ADDENDUM NO. 1

ISSUE DATE: April 4, 2018

CRC College Center Expansion

LRCCD BID NO. 17021

SHEET NO:
A2.15

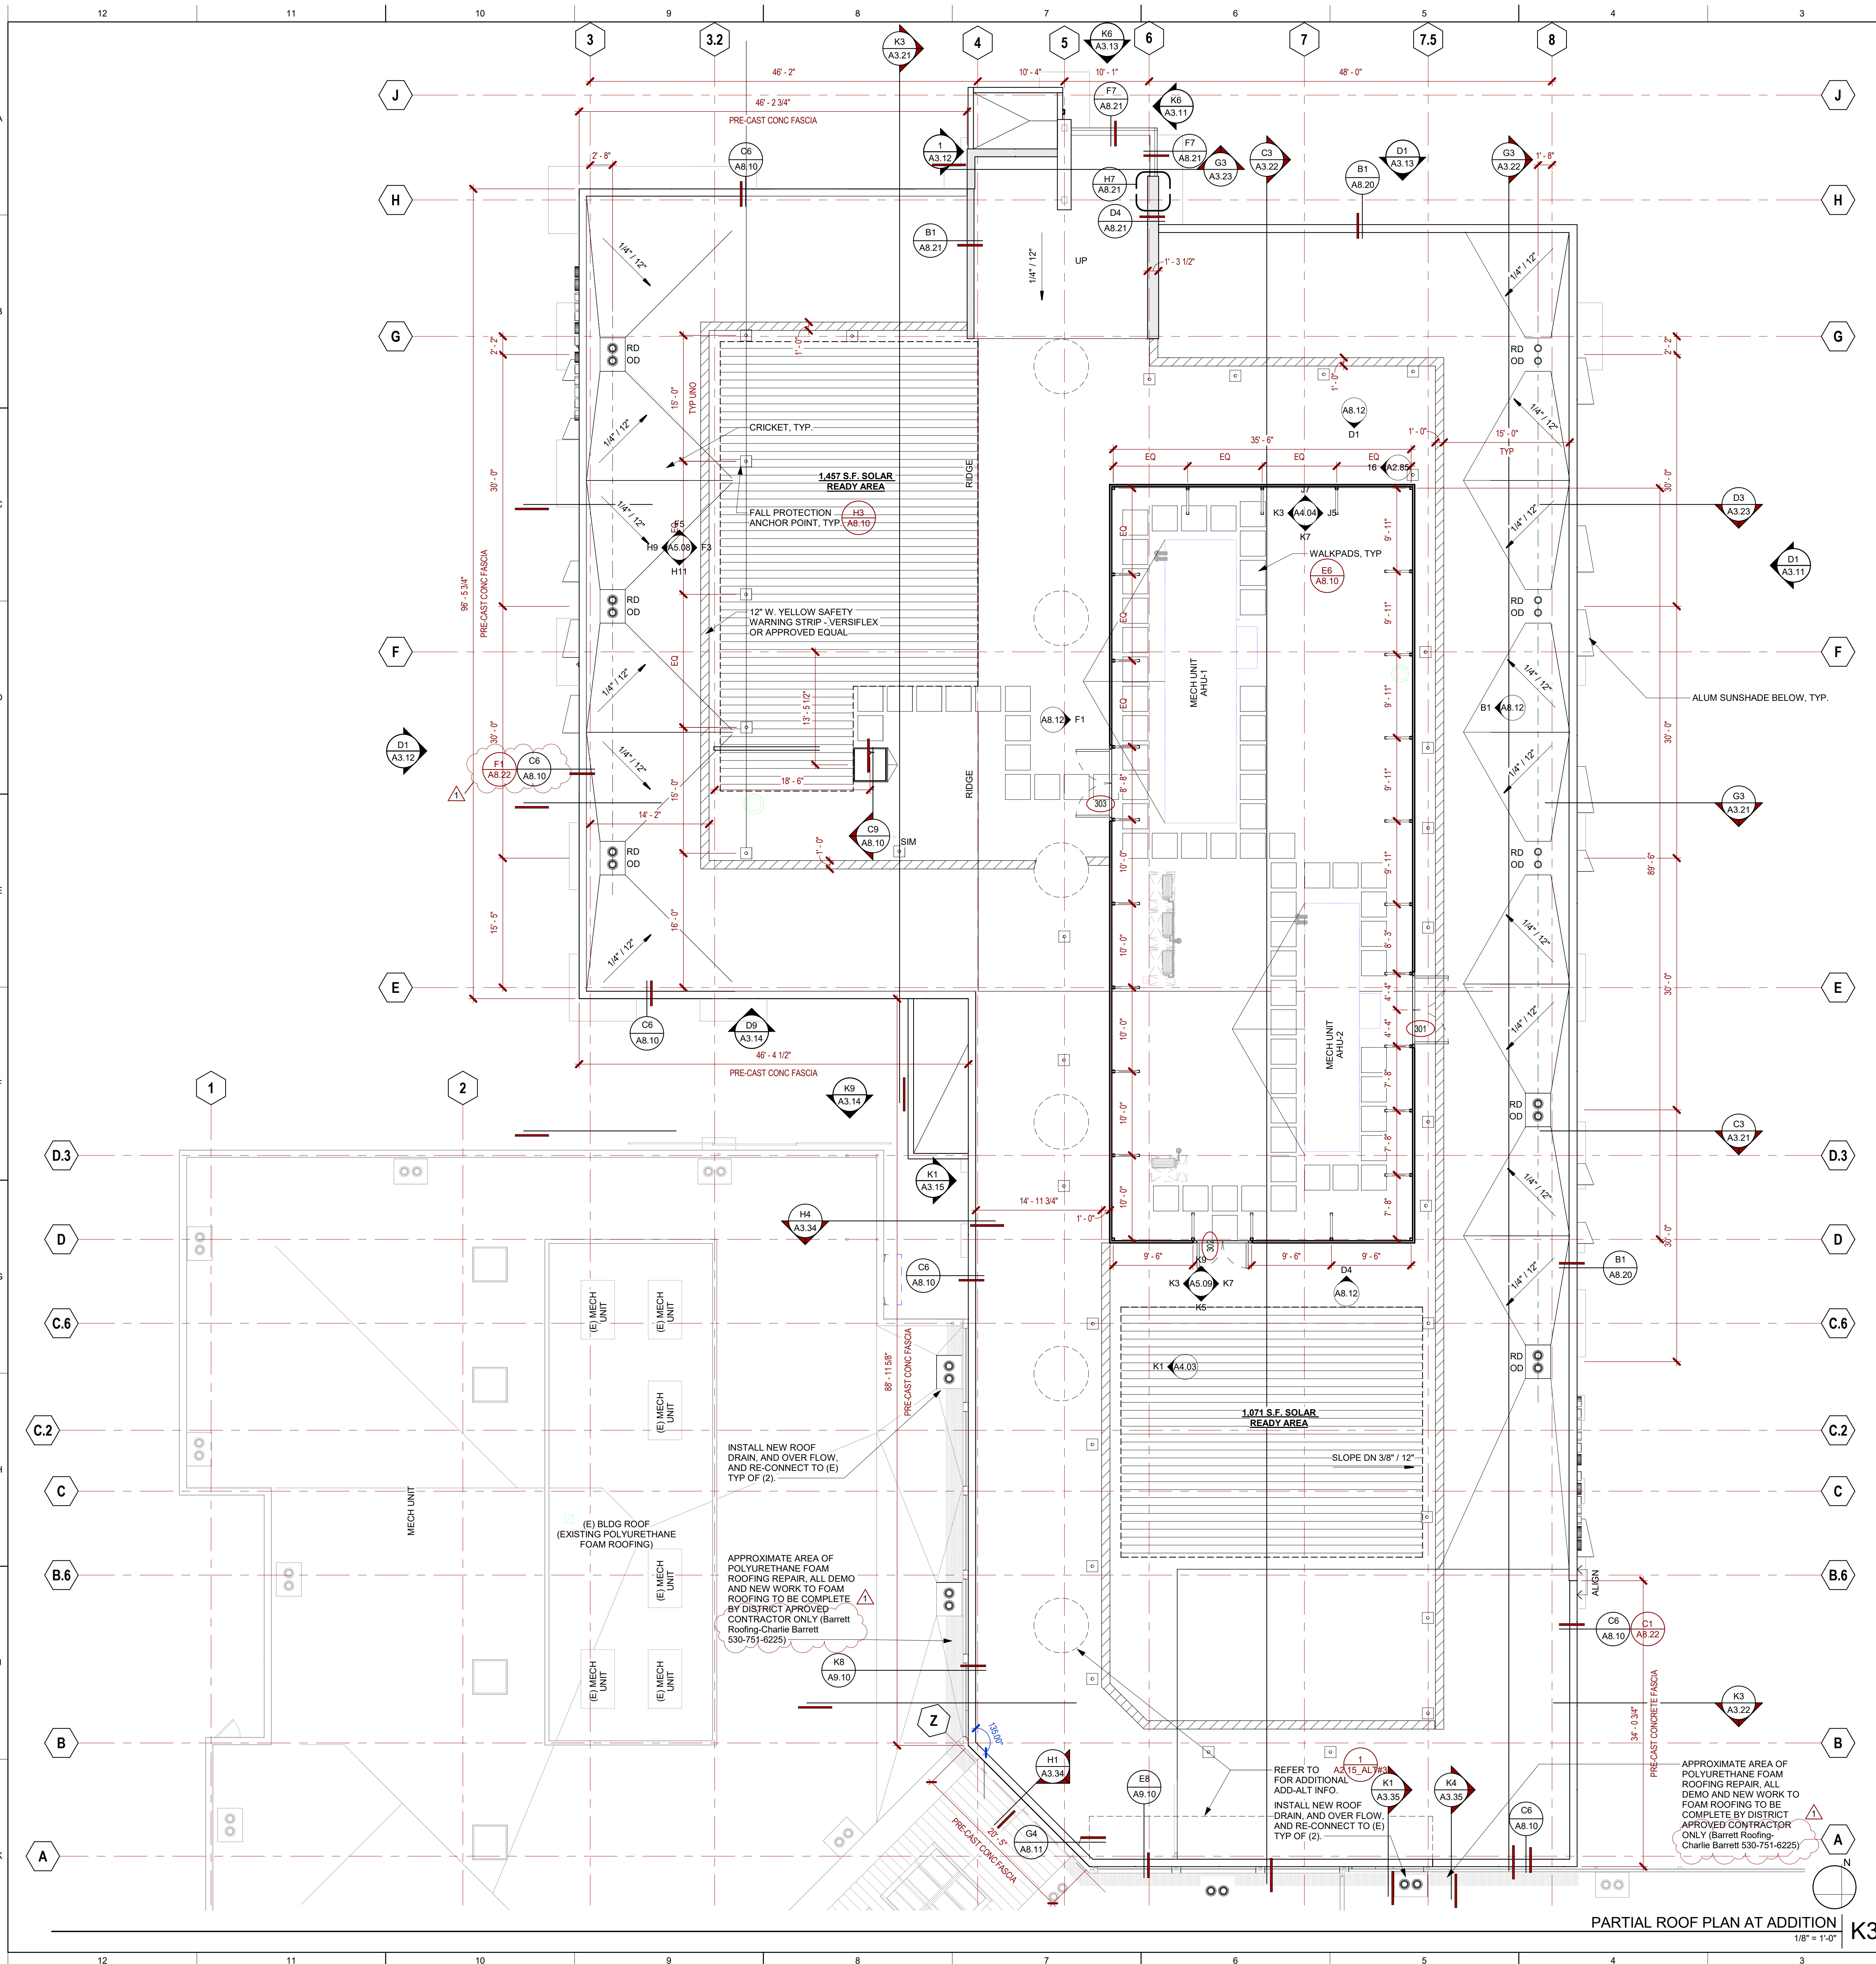
A2.01B – Modified scope of work boundary lines, general notes, floor plan symbols legend
A2.02 - Modified railing at stairs, walls at Open Office 254
A2.15 – Modified contractor contact information, detail tags
A2.30 – Modified finish material legend, wall combinations notes, general notes
A2.31A – Modified finish plan symbols, reception deck at reception 161Q, and updated finish tags
A2.31B – Removed graphics, finish plan symbols
A2.32 – Modified finish plan symbols, wall and deck at Open Office 254, and finish tags
A2.43 – Modified remarks column
A2.44 – Modified detail B9
A2.81 – Modified door schedule, door finish legend, door types, add fire curtain schedule

A2.83

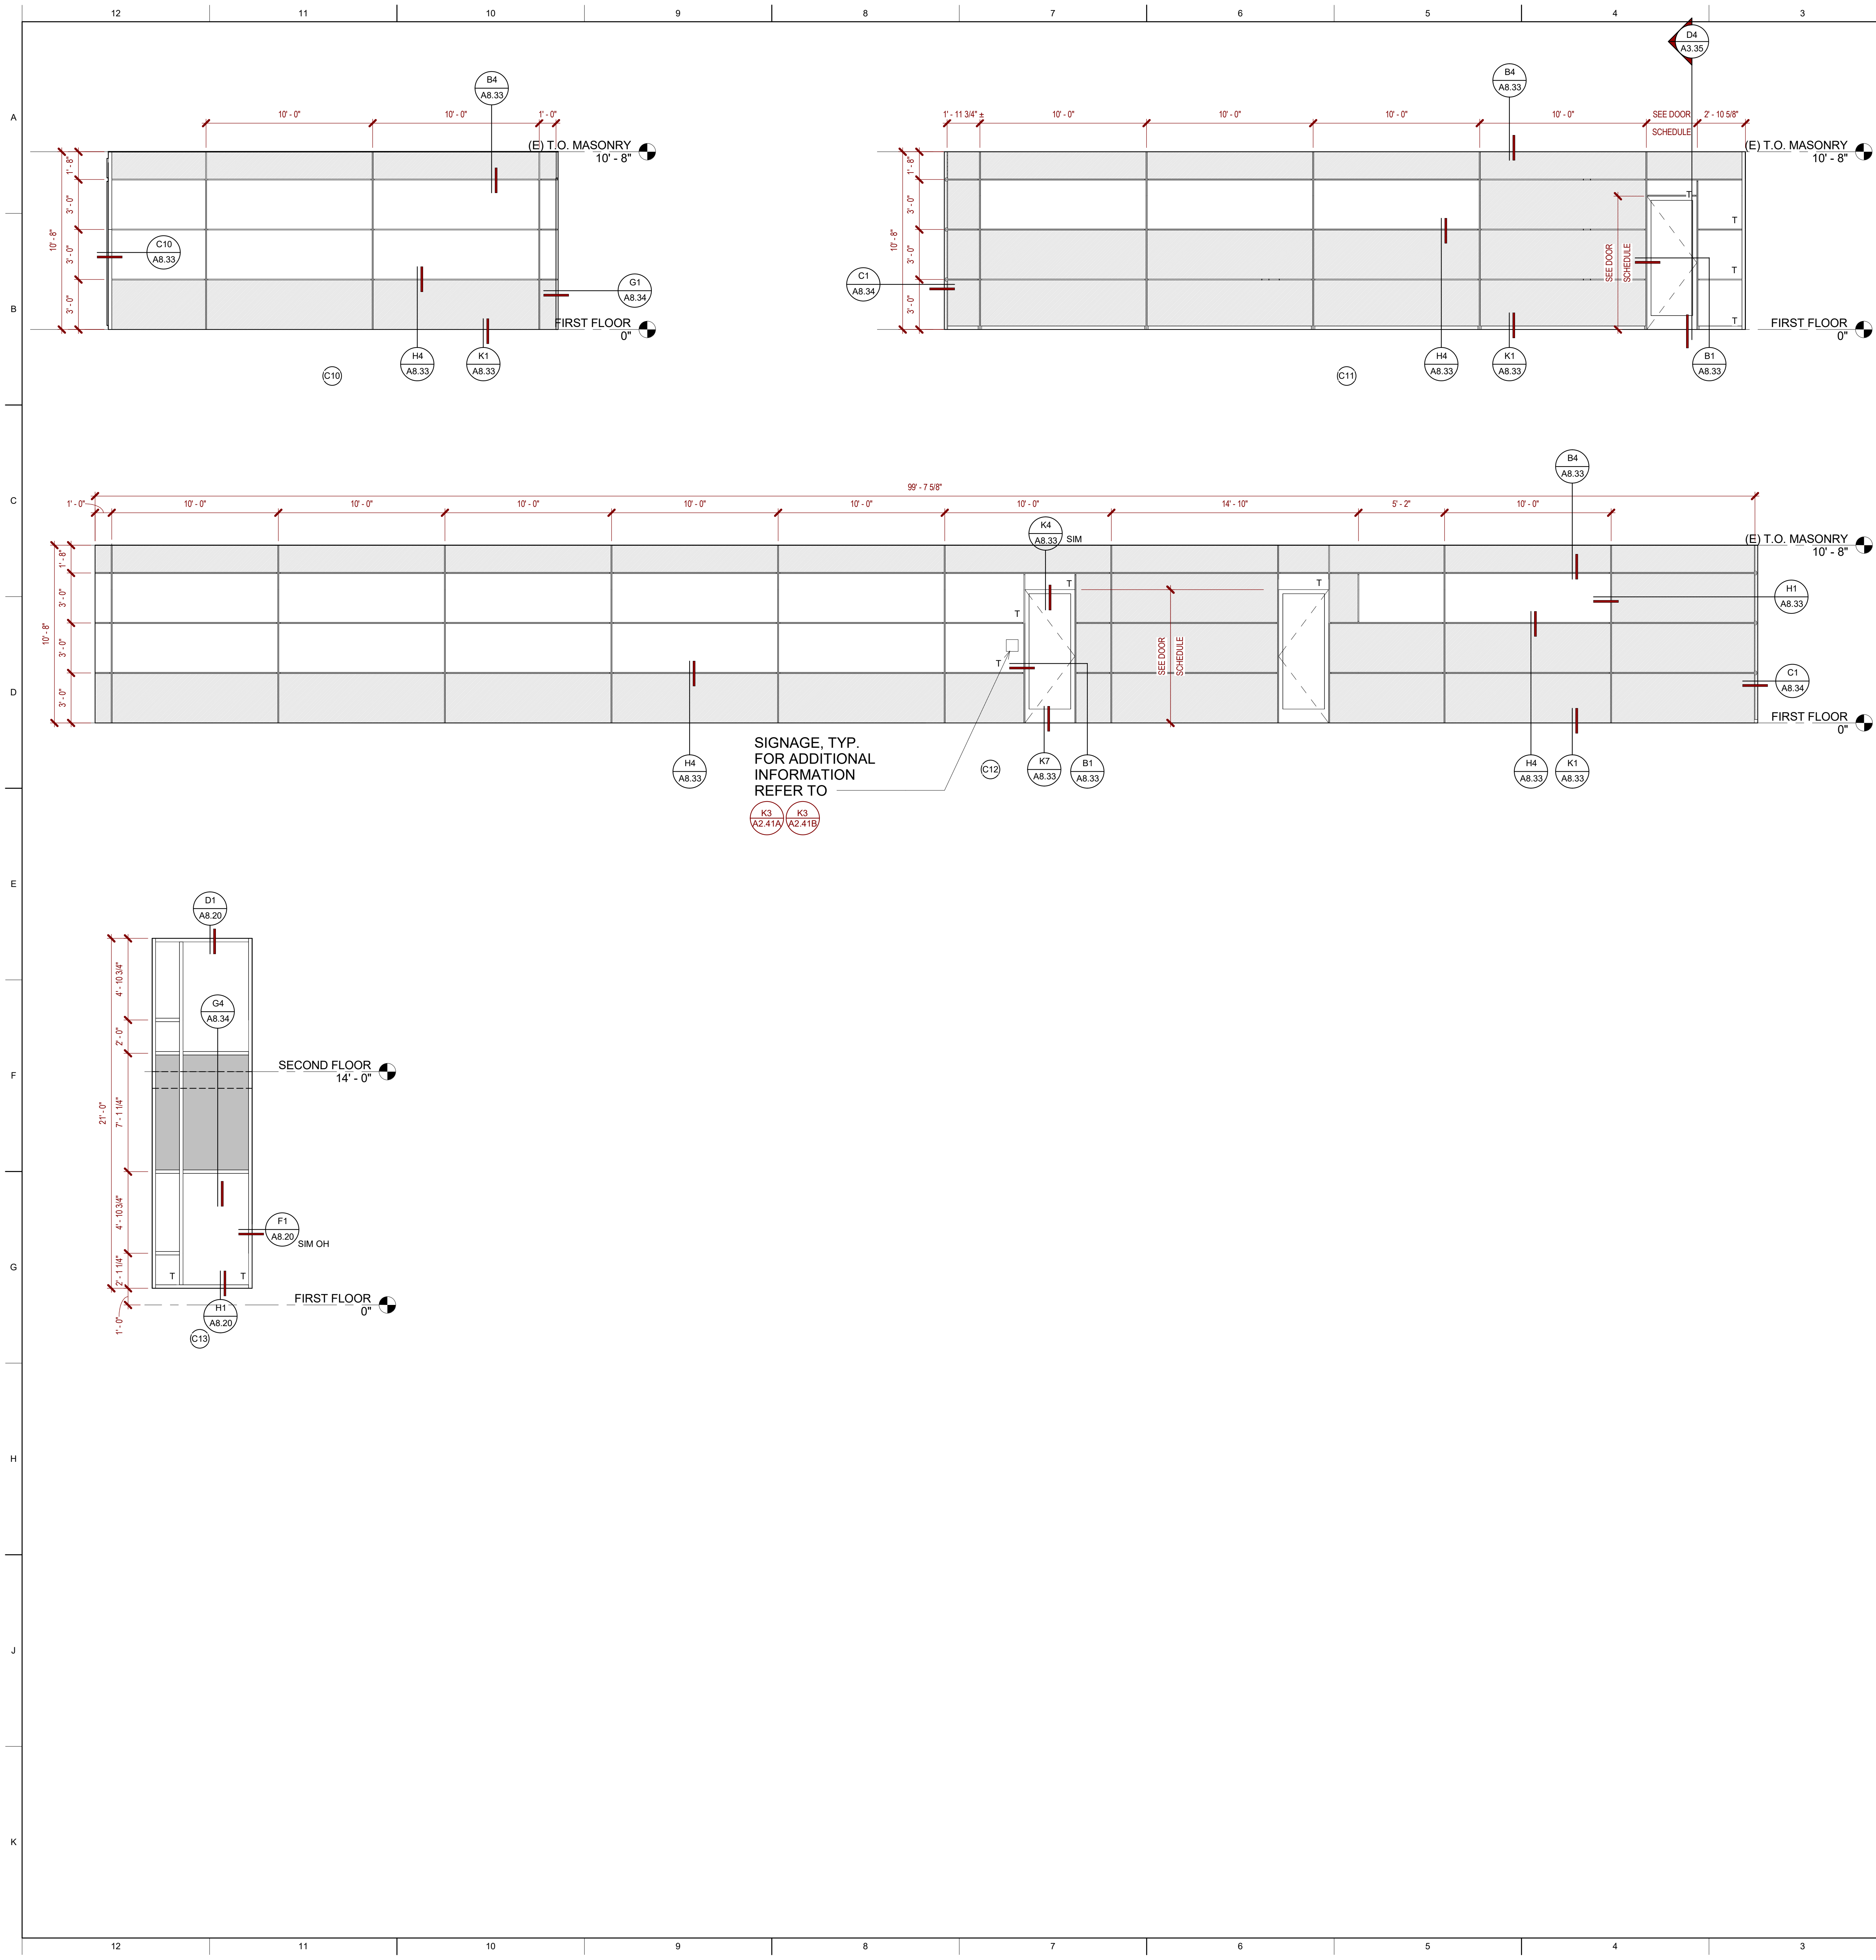
- A2.82 – Modified general notes
- A2.83 – Modified general notes
- A2.84 – Modified general notes
- A2.85 – Modified general notes, storefront type IS15
- A3.11 – Modified “Exterior Finish Legend”
